RE: Comments on the Hanford Site's 5-Year Plan (2025-2029)

Riverkeeper and Oregon PSR (collectively "Commenters") submit the following comments on the Hanford Site's 5-Year Plan (2025-2029).

Re: Proposed Changes to the Tri-Party Agreement and Consent Decree Public comment Period. The Future of Tank Waste Cleanup at the Hanford Site.

Source: Pacific Northwest National Labs. PHOENIX database. Groundwater well explorer.

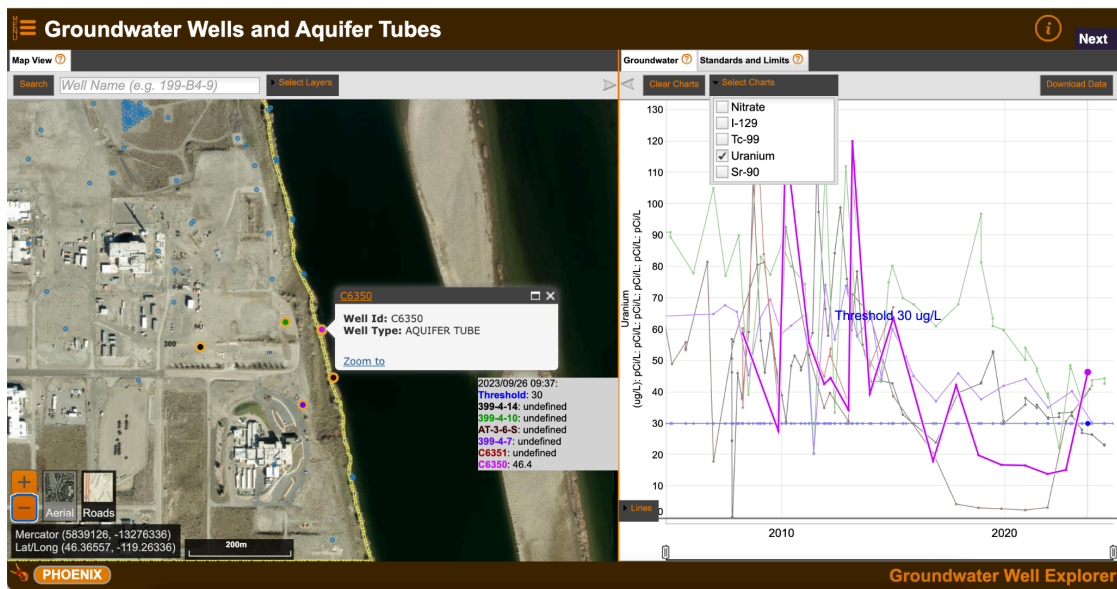
down for the next five years, Commenters are concerned that these concentrations will remain well above the safe drinking water standard. The image below depicts the concentration levels present in well 199-N-67. Energy must be clear to the public that contamination from Hanford currently reaches the Columbia River.

The drinking water standard in Washington State is 8 pCi/L. At the levels present in groundwater, Sr-90 and Cr(VI) in the River Corridor risk the health and safety of fish, animals, plants, and people who depend on them. The TPA agencies are responsible for informing the public. In addition, agencies are only now beginning to grapple with EPA's acknowledgement that hexavalent chromium is highly carcinogenic through the oral exposure route. *Why has there been no public education on this?* TPA Agencies should be prepping the public now on what that means, so that there is active and informative engagement during any public process for the River Corridor.

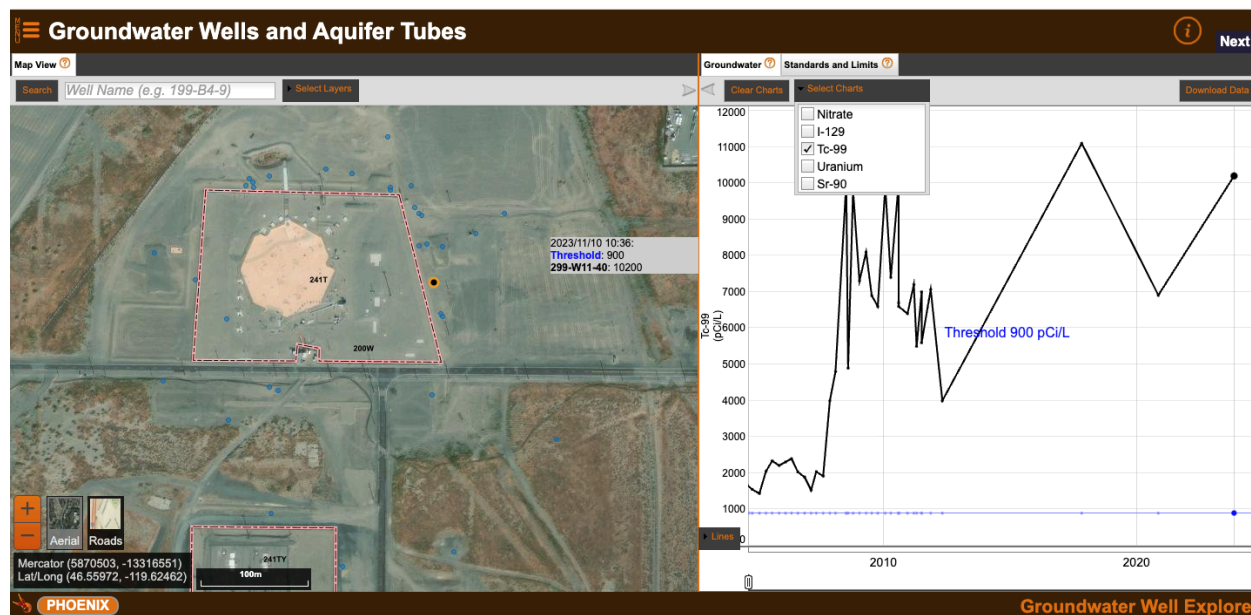
Data available on PHOENIX underscore ODOE’s concern regarding the long-term impact of Tc-99 and I-129. The figure below includes data from a well near the T Farm which exceeds groundwater standards by an order of magnitude.

The ongoing Tc-99 problem in the Central Plateau underscores the importance of creating adequate and timely tank space and focusing on improving the ability of Energy to move tank waste towards effective treatment and immobilization facilities, many of which are still in planning.
